Upgrade of the Chester Hill Resource Recovery Facility (MP_0052)

Response to Submissions

Prepared for Builders Recycling Operations Pty Ltd

February 2019

Figure 1 – Ground Site Plan showing area to be deleted

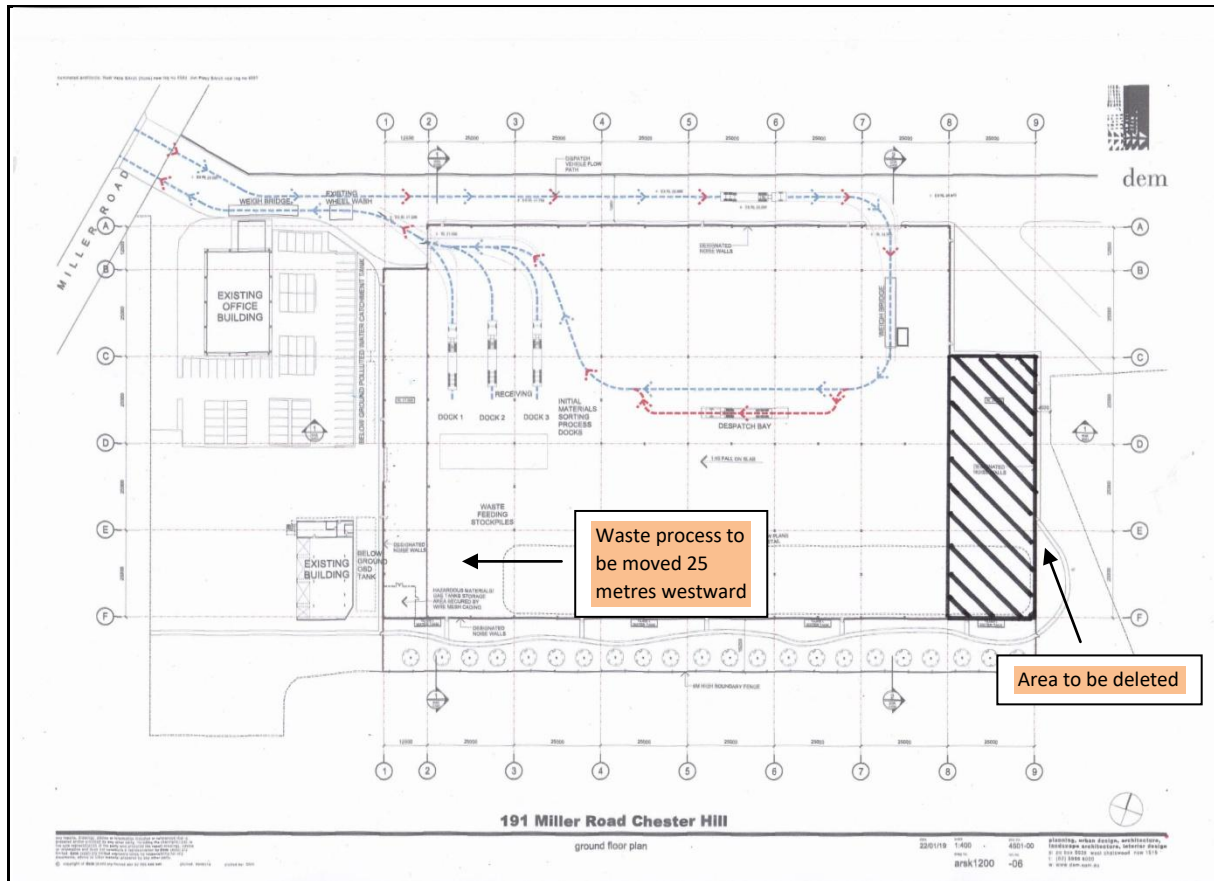
A review of the current size of the enclosure and in particular the need to ensure a minimum of 6 metres around the building for firefighting purposes has necessitated a minor design modification in the enclosure resulting in the eastern edge of the enclosure being reduced by approximately 25 metres from the boundary. The deletion also requires the waste process to be moved 25 metres westward as depicted in Figure 1. An updated site layout showing the amended building and waste process is provided at Figure 2. All relevant plans have been updated and included in Appendix A.

The redesign would have negligible impact on operational aspects of the proposal but would result in a reduction in the bulk and scale of the enclosure. The new dimensions of the enclosure would be 162.5 metres long by 112.50 metres wide equating to 18,281.25 square metres of floor space, a reduction in 1,875 square metres. The reduction would increase the setback to the eastern perimeter by 25 metres enabling more than adequate space for firefighting access and superior landscaping outcomes.
